2021 GROUP A PUBLIC COMMENT AGENDA

SEPTEMBER 21 - 28, 2021  
DAVID L. LAWRENCE CONVENTION CENTER  
PITTSBURGH, PA

## 2021 Public Comment Agenda

**FIGURE 1207.11.7.1 ESS VEHICLE IMPACT PROTECTION**

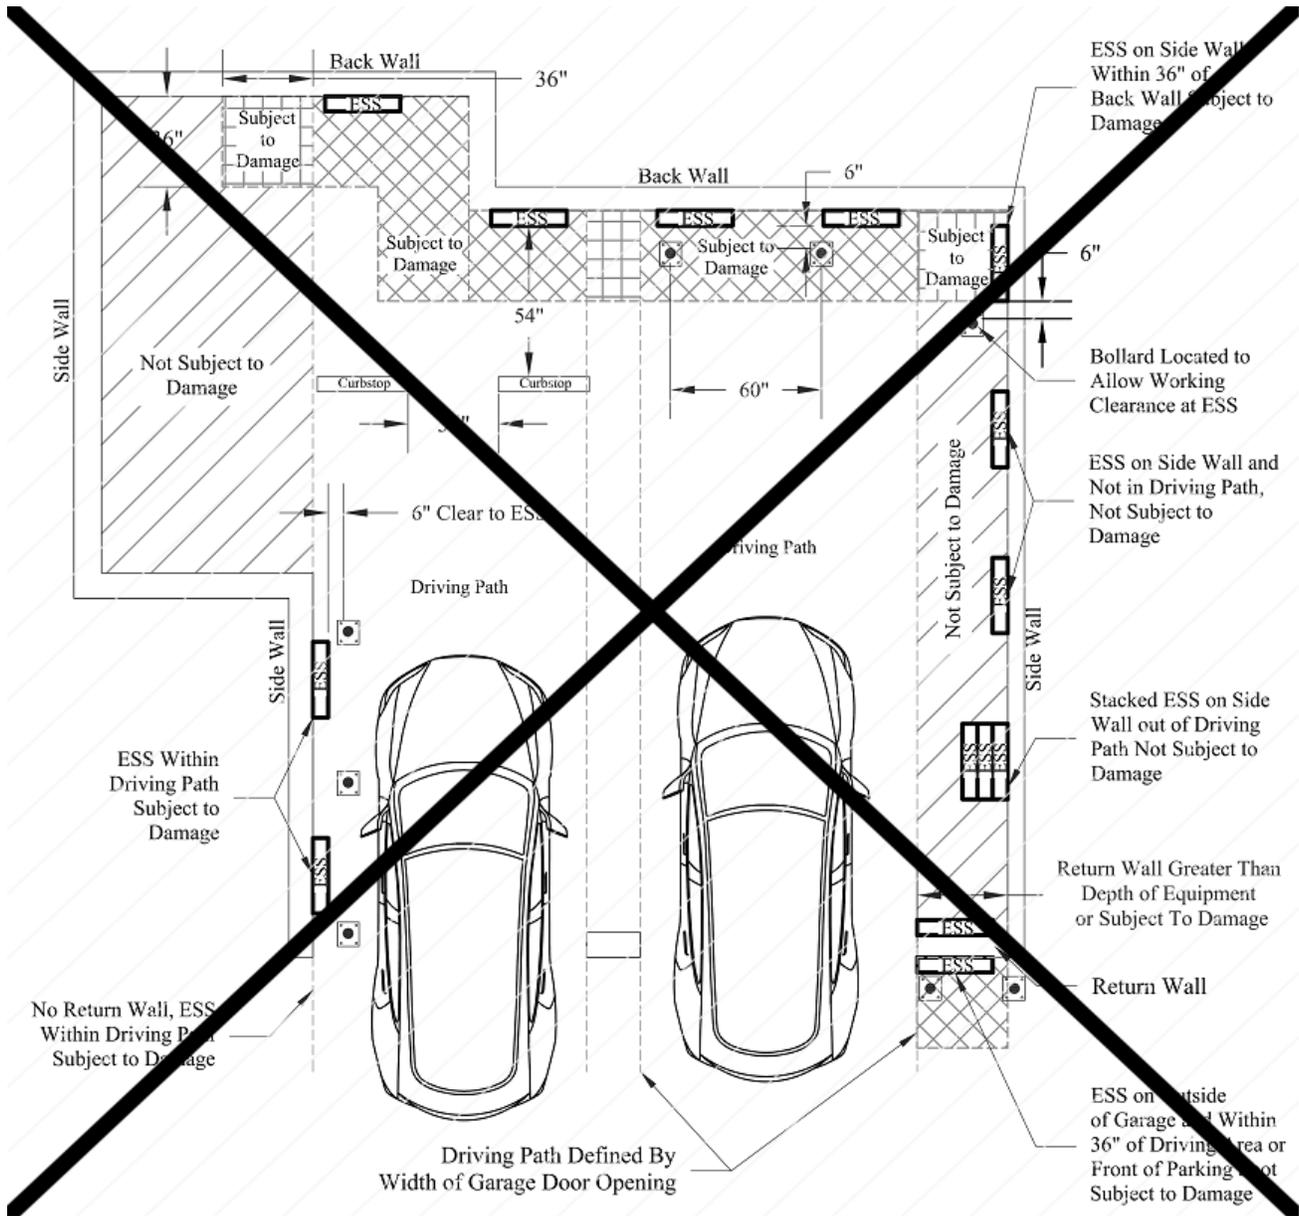
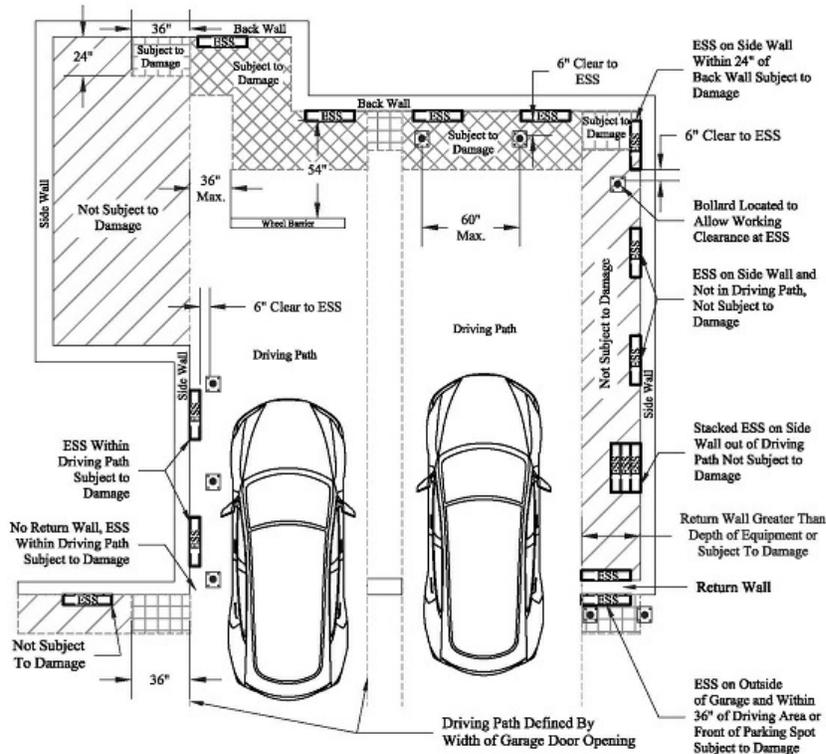
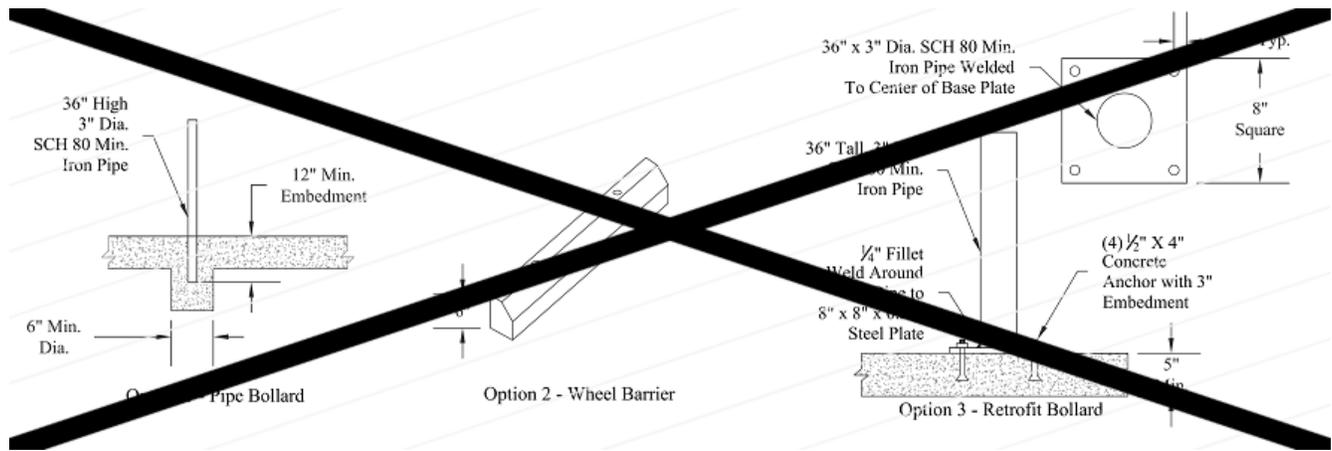
5. Further refine Figure 1207.11.7.1:
  1. Add an ESS on an exterior wall not subject to damage as an example
  2. Align terminology - replace "curb stop" with "wheel barrier"

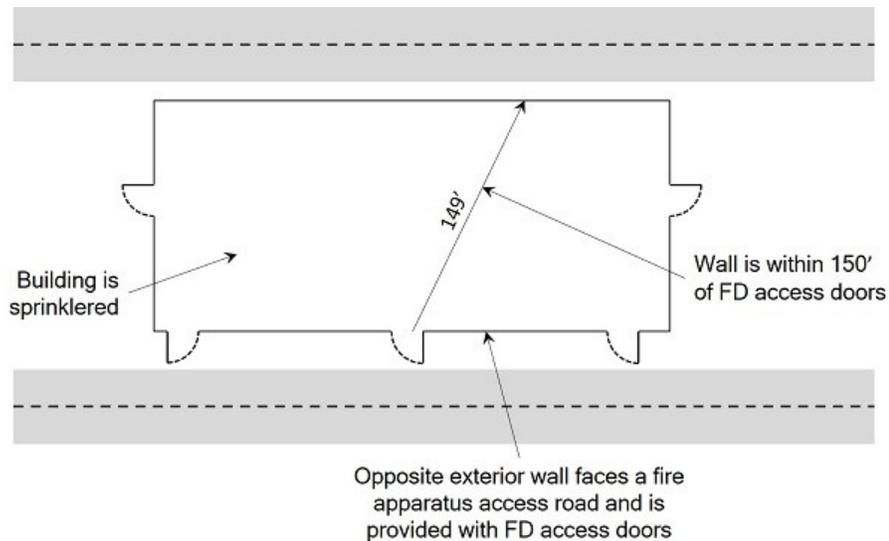
**Commenter's Reason:** It is unfortunate that the recent rewrite to Chapter 32 created an unintentional conflict for the requirements for fire department access doors. The original proposal was designed to remedy this conflict, however, it is such a subtle conflict that the Code Development Committee did not recognize that the conflict exists. This Public Comment urges Approval as Submitted.

IFC Sections 3206.7.1 and 3206.7.2 each work fine as stand alone sections. It is when you attempt to apply them together that the conflict occurs. Current text in IFC Section 3206.7.2 only requires FD access doors in exterior walls facing a fire apparatus access road. This means that if an exterior wall does not face an access road, then FD access doors are not required. This section is very clear, however, Section 3206.7.1 states that the FD access doors can only be eliminated if a list of criteria is met in addition to the fact that it does not face an access road. So one section says FD access doors are not needed and the other section says the FD access doors are not needed if you meet certain criteria. The list of criteria is actually intended to be an exception allowing an exterior wall of a narrow building to be without FD access doors.

FIGURE 4005.2.3.6(5)-4005.2.3.6(4) IN-RACK SPRINKLER LAYOUT FOR DOUBLE ROW RACK OF ON-END WOODEN BARRELS

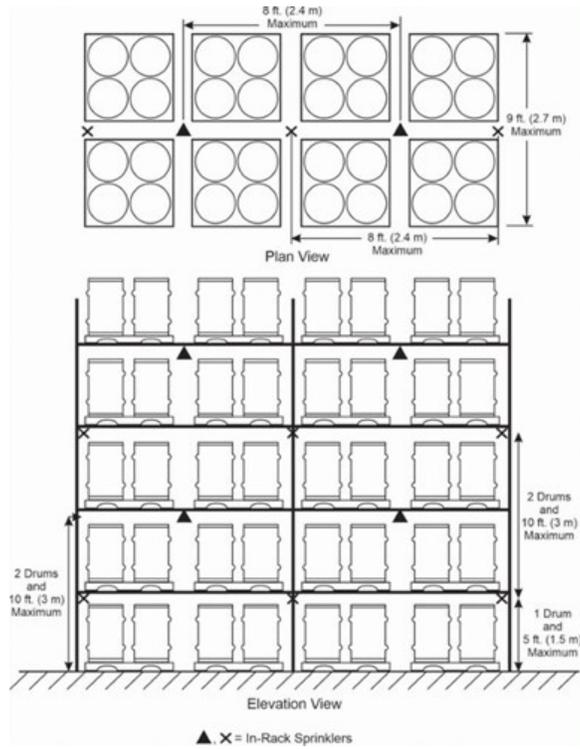
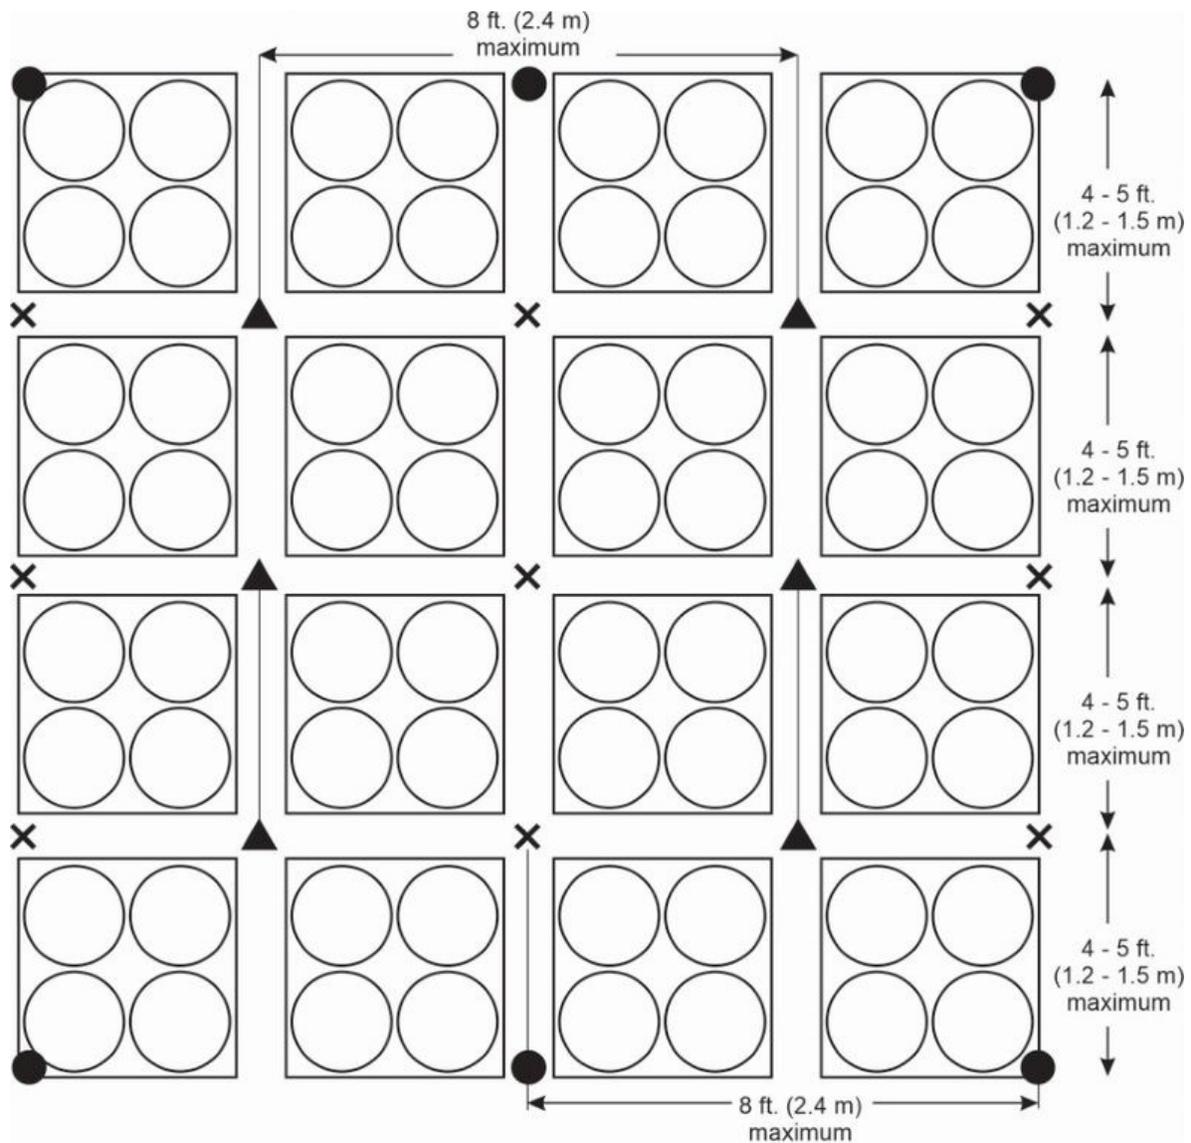
**Committer's Reason:** The purpose of this PC is simply editorial. First it removes an unnecessary Figure from the table and the proposal. Additionally, the plan view of what is now numbered as Figure 4005.2.3.6(5) was omitted in the original proposal and has been added by this PC.

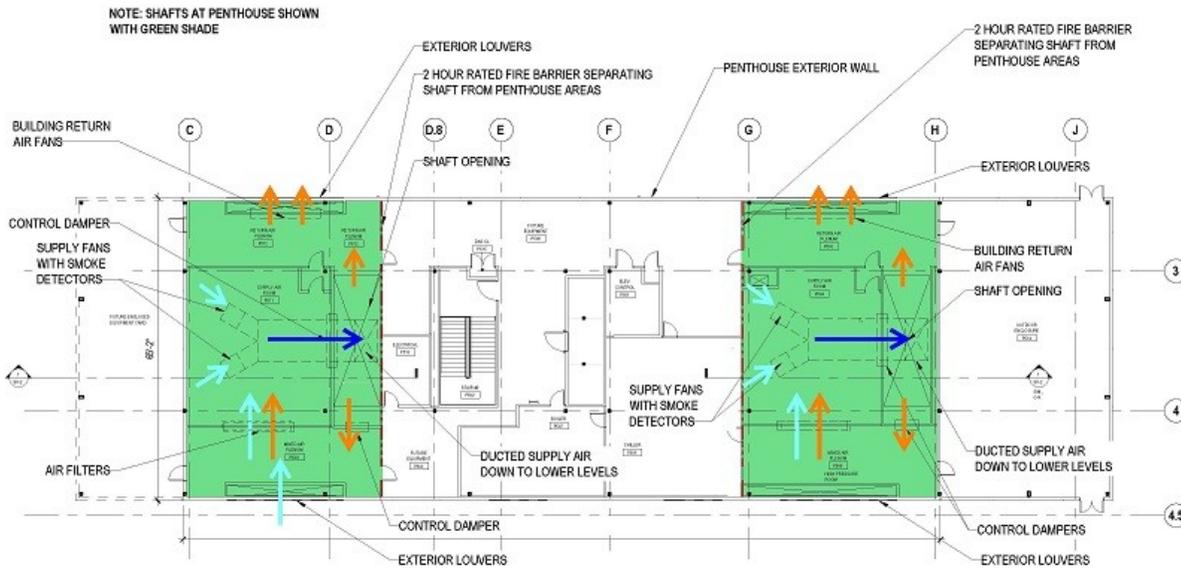
**Commenter's Reason:** The mechanical HVAC system design where the supply or exhaust air is conveyed via an internal building shaft, to or from the mechanical penthouse, may not actually be provided with a mechanical duct system for the design of the HVAC system. The removal of the last sentence of the provision above does not appear to be relevant if the HVAC system under consideration follows the other existing code provisions and is thereby found acceptable to the AHJ approving the submitted design drawings.

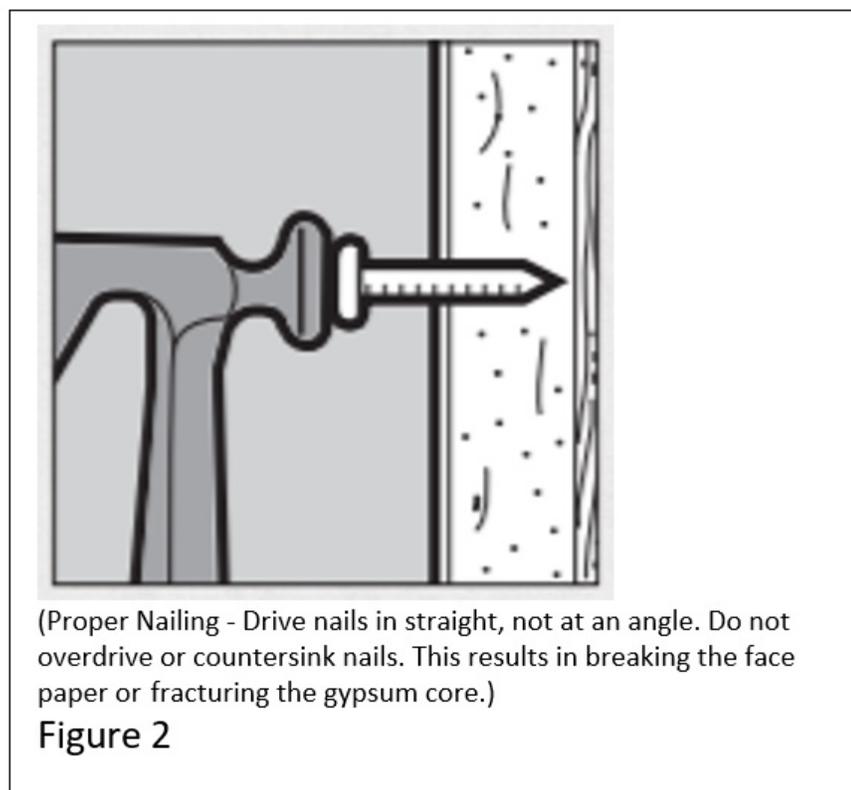
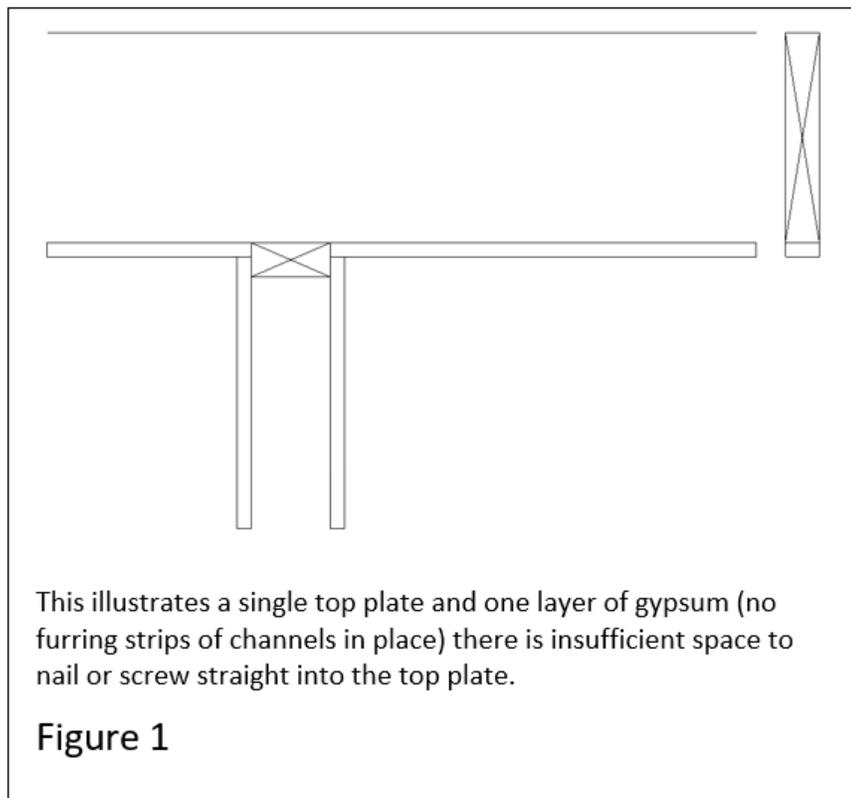
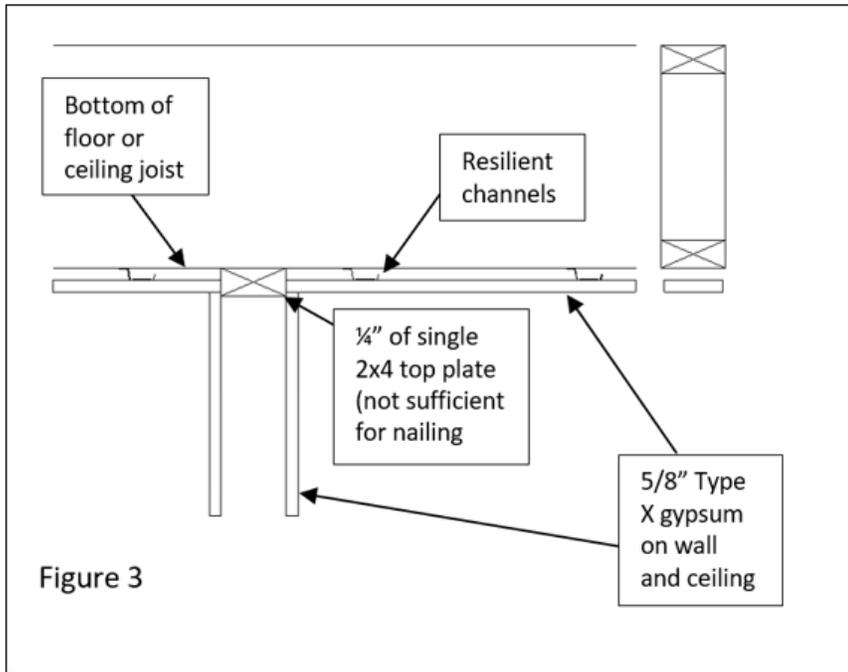
**Commenter's Reason:** In looking more closely at the impact of this proposal we have identified unintended consequences that make it problematic to implement this construction for wood stud walls. For the reasons explained below, we urge Disapproval of FS67-21 because this change leads to an unforeseen consequence of improper constructability.

This construction method decreases the depth of the wood surface needed at the top of the wall to properly fasten the gypsum material. In the case of the single top plate with a single layer of 5/8" attached to the ceiling or floor joists above (see figure 1) the remaining wood surface would be 7/8 of an inch or less and would not allow for nails or screws attaching the gypsum to be driven in straight, as required for proper attachment (see figure 2). Securing gypsum with fasteners driven at an angle results in breaking the face paper or fracturing the gypsum core.

Many fire-resistance rated ceiling designs require the use of resilient channels and this proposed construction method further reduces the available surface for nailing. Figure 3 illustrates an additional reduction of 3/4 of an inch of fastening surface on the top plate, leaving only 1/4 inch of wood surface accessible below the gypsum on the ceiling. This proposed code change results in too little nailing surface for the gypsum on the wall at the top plate resulting in construction where the gypsum cannot be properly fastened as required for the construction.
